HISTORIC AND DESIGN REVIEW COMMISSION

HDRC CASE NO: 2020-470
ADDRESS: 2300 BROADWAY
LEGAL DESCRIPTION: NCB 3857 BLK LOT 9 EXC NE IRR 15FT
ZONING: I-1, RIO-1
CITY COUNCIL DIST.: 2
DISTRICT: Westfort Historic District
APPLICANT: Patrick Spencer/DALLENBACH-COLE ARCHITECTURE
OWNER: Robert Fisher/SOVRAN ACQUISITION LTD PARTNERSHIP
TYPE OF WORK: New construction of a 2-story storage structure
APPLICATION RECEIVED: October 15, 2020
60-DAY REVIEW: Not applicable due to City Council Emergency Orders
CASE MANAGER: Edward Hall

REQUEST:

The applicant is requesting conceptual approval to construct a new 2-story, climate controlled storage structure. Improvements to the site will include utility work, landscaping, hardscaping and signage. The applicant has noted that signage will be submitted at a separate time. The proposed new construction will require the demolition of the existing storage structure. This demolition is eligible for administrative approval.

SITE PLAN

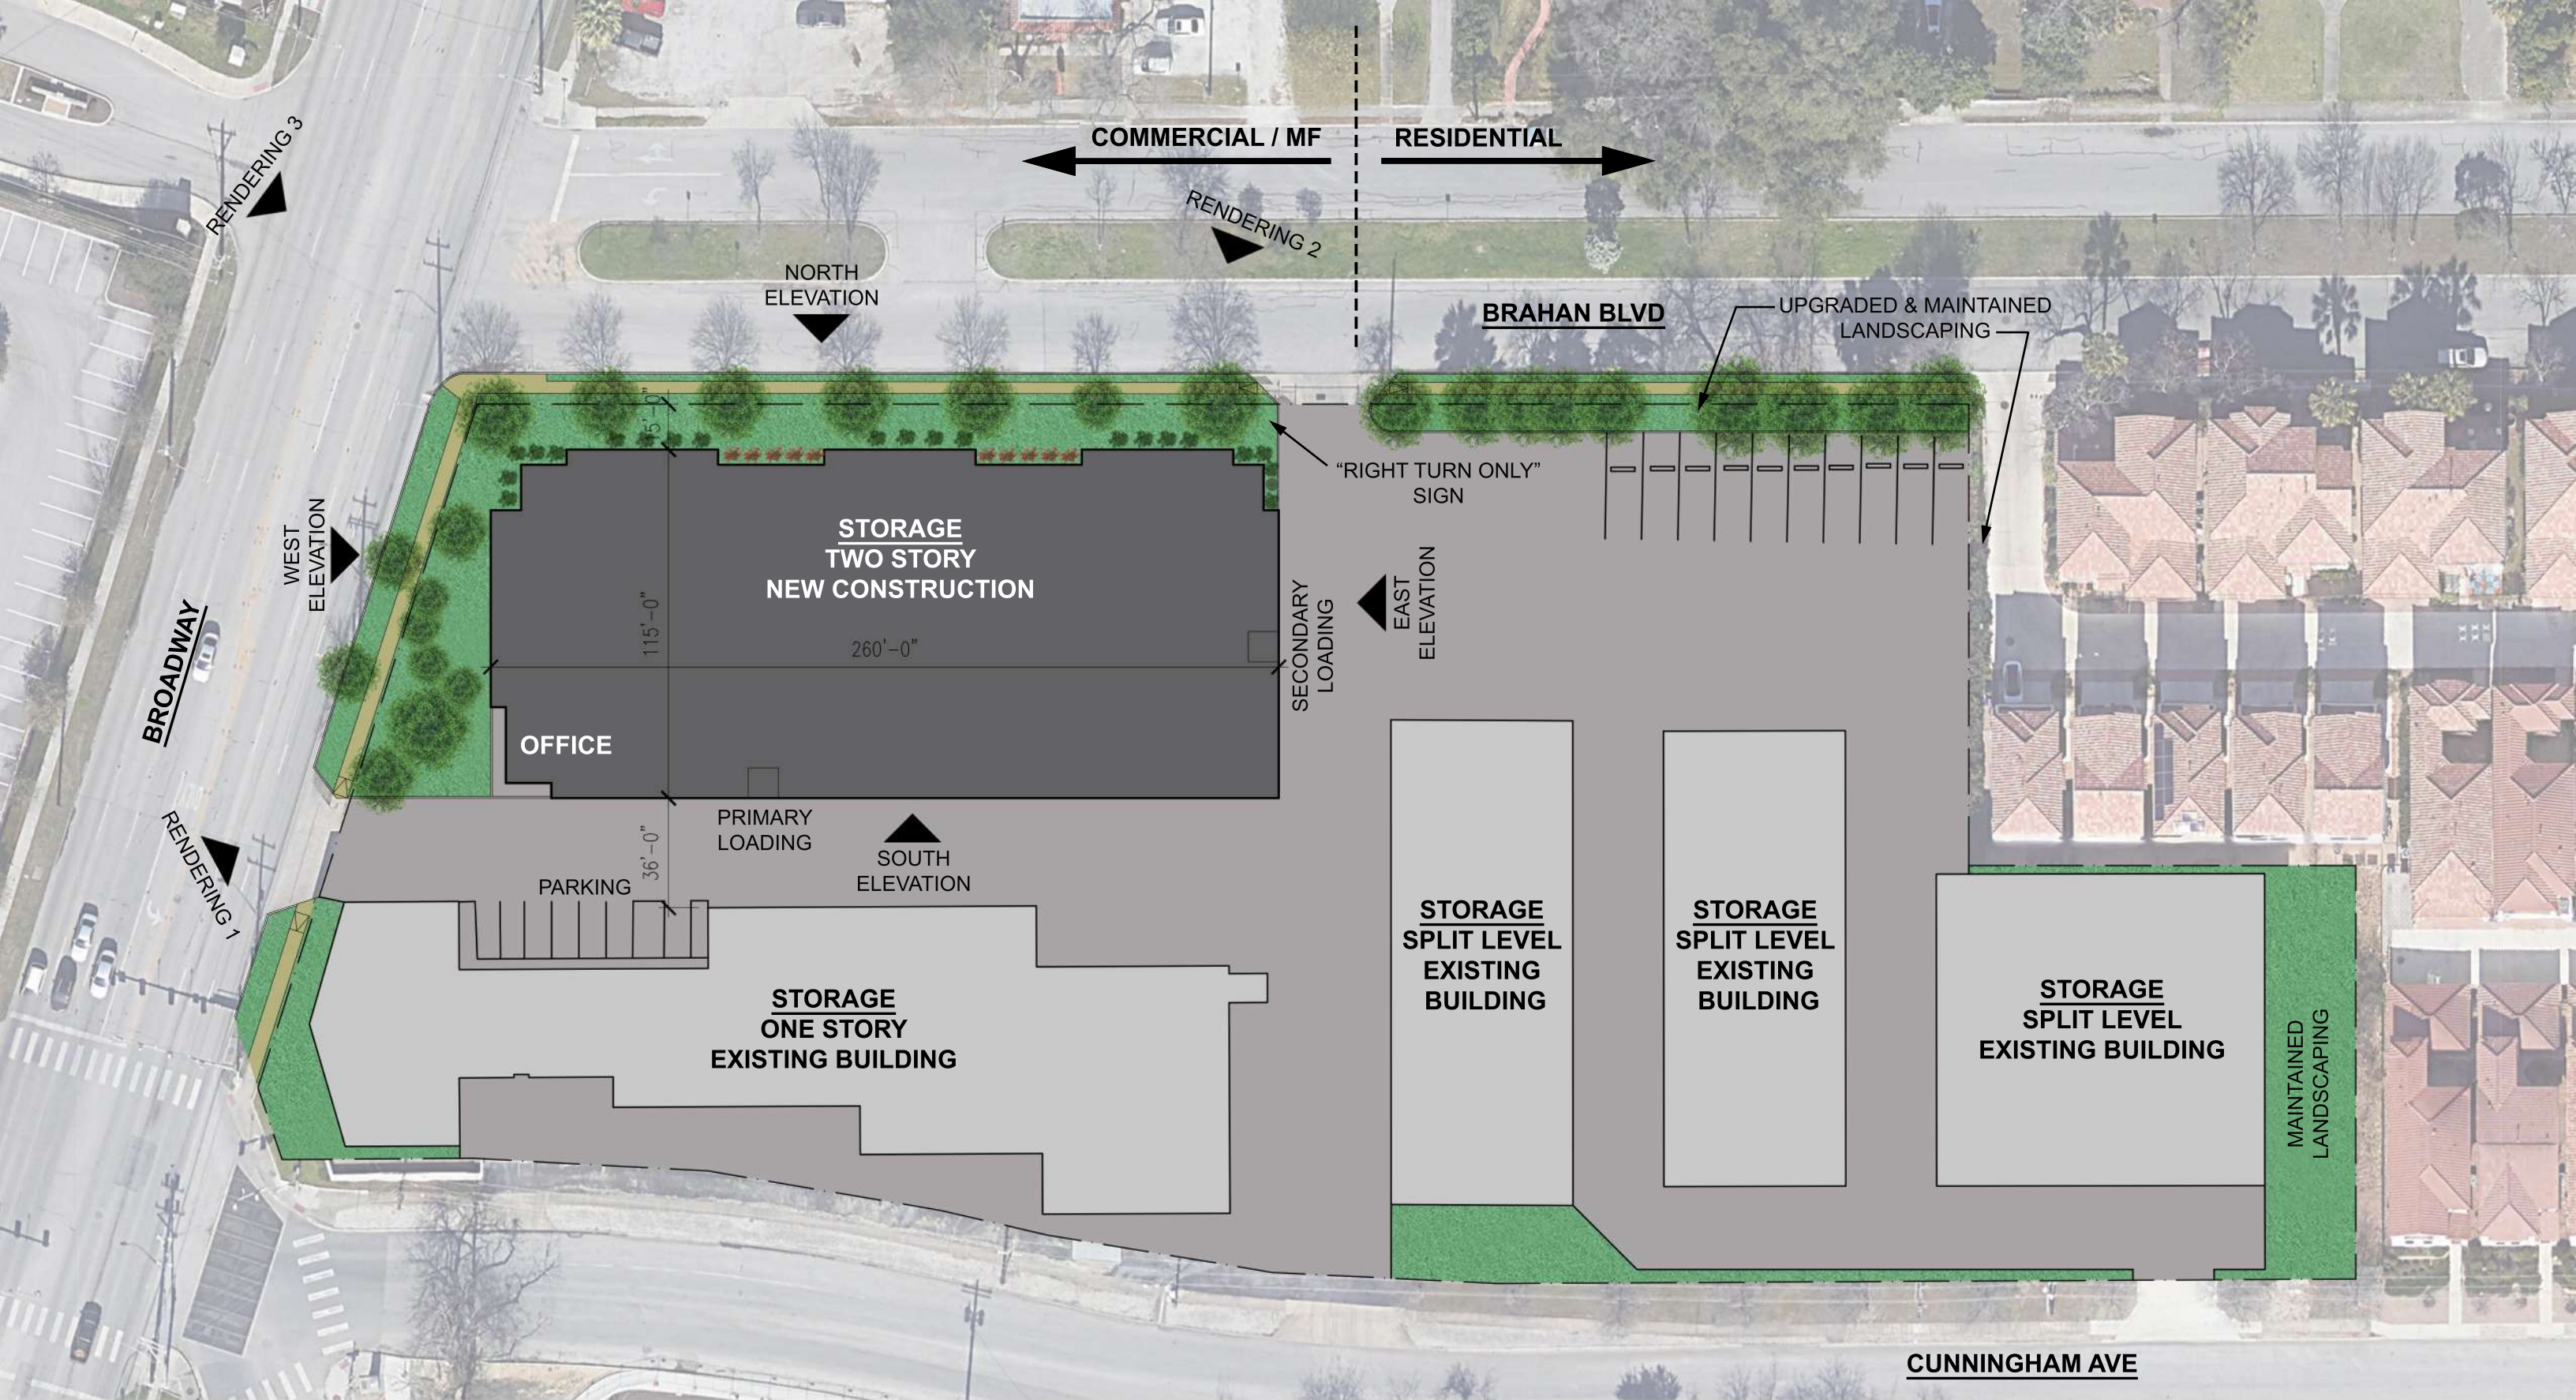
JF: Show structures that will be demolished on new site plan to show that new structure is closer to Broadway than the existing.

WEST ELEVATION - FROM BROADWAY

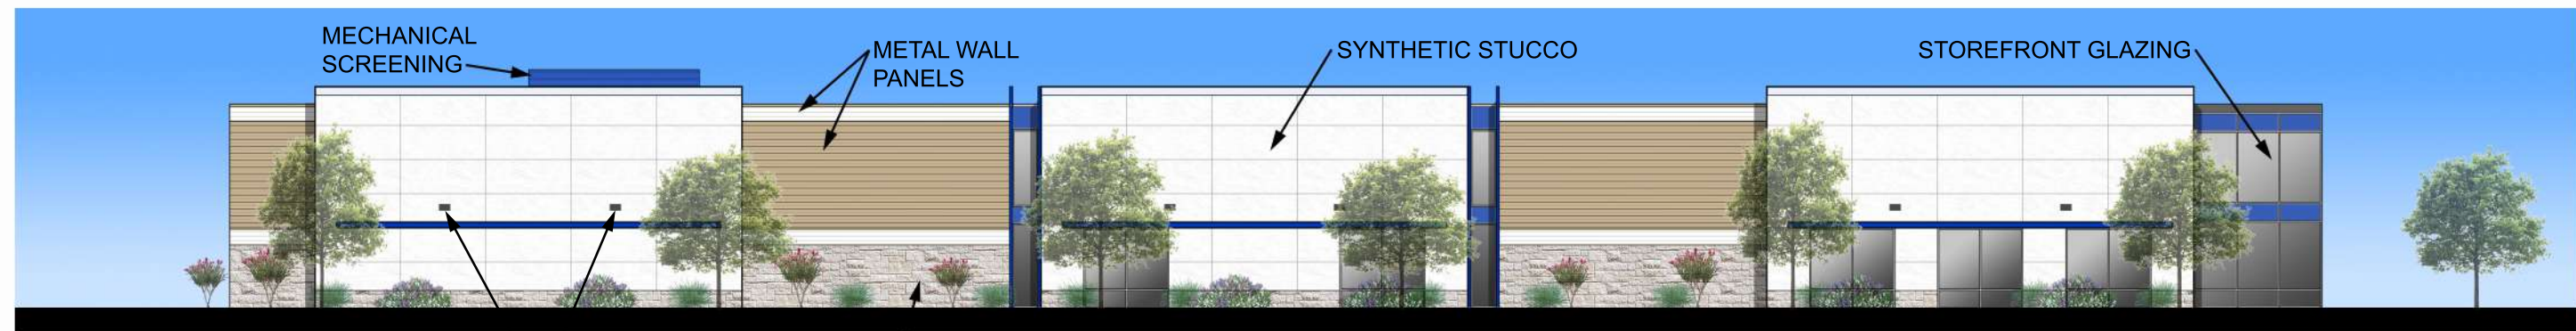
- h. **SITE DESIGN** – According to the UDC Section 35-673, buildings should be sited to help define active spaces for area users, provide pedestrian connections between sites, help animate the street scene and define street edges. Primary entrances should be oriented toward the street and shall be distinguishable by an architectural feature. The applicant has proposed to locate the primary pedestrian entrances on the south elevation, which faces the existing parking and existing commercial building. Staff finds that an entrance and architectural entrance elements that face Broadway would be consistent with the UDC.

- k. **HUMAN SCALE** – According to the UDC Section 35-674(b) a building shall appear to have a “human scale”. To comply with this, a building must (1) express façade components in ways that will help to establish building scale, (2) align horizontal building elements with others in the blockface to establish building scale, (3) express the distinction between upper and lower levels (4), divide the façade of the building into modules that express traditional dimensions and (5) organize the mass of a building to provide solar access to the river. The applicant has incorporated human scaled elements on both street facing facades including storefront systems, façade materials and façade openings. Generally, staff finds the proposed design elements to be appropriate; however, staff finds that the applicant should continue to study additional human scaled elements.

NORTH ELEVATION - FROM BRAHAN BLVD

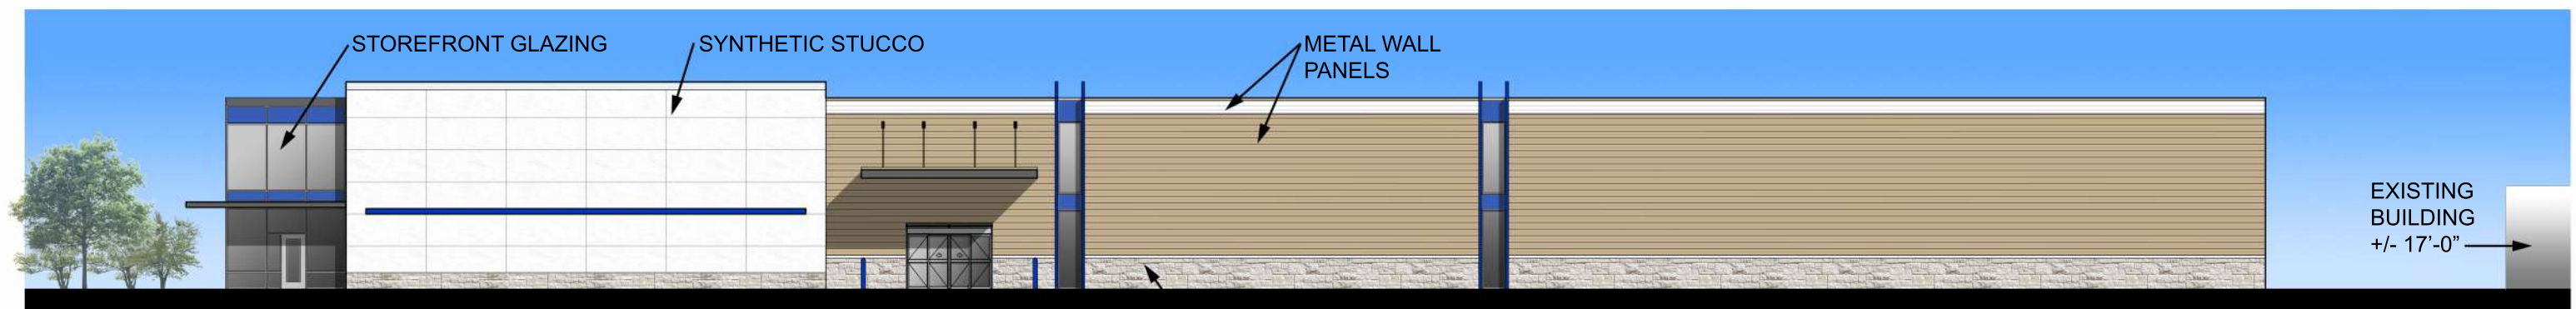
JF: Add detail to the elevation along Brahan (include wrought iron fencing)

CF: Additional fenestration should be added to the Brahan elevation
